Amendments to the Drawings:

FIG. 11

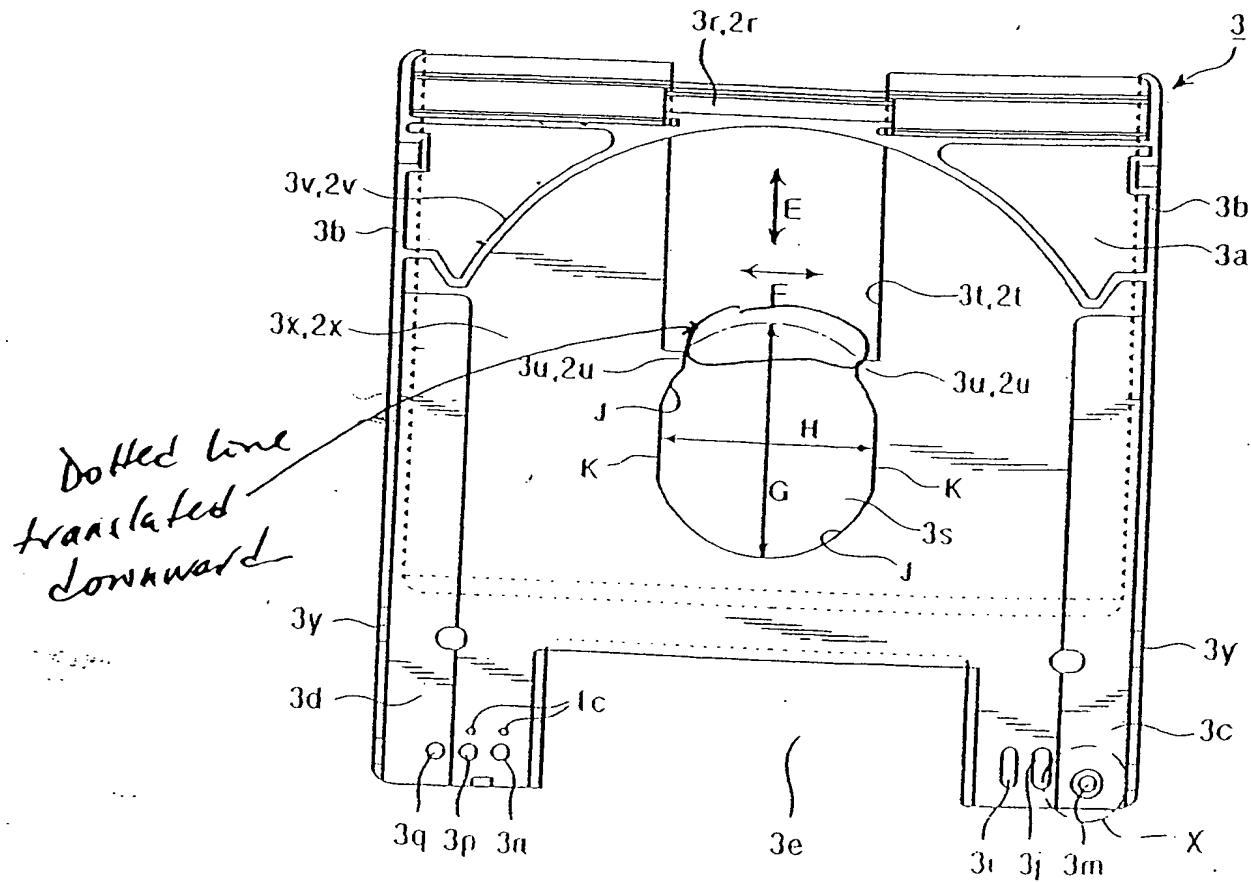
The attached sheets of drawings include changes to Figure 11. The enclosed annotated sheets show the changes to Figure 11 and the replacements sheets will replace the latest filed drawing sheets. With respect to the changes to Figure 11, the 'imaginary' (dot-dash lined portion) arcuate portion forming an endpoint of 'G' has been translated 'downward' to the circle defining the arcuate portions 'J'.
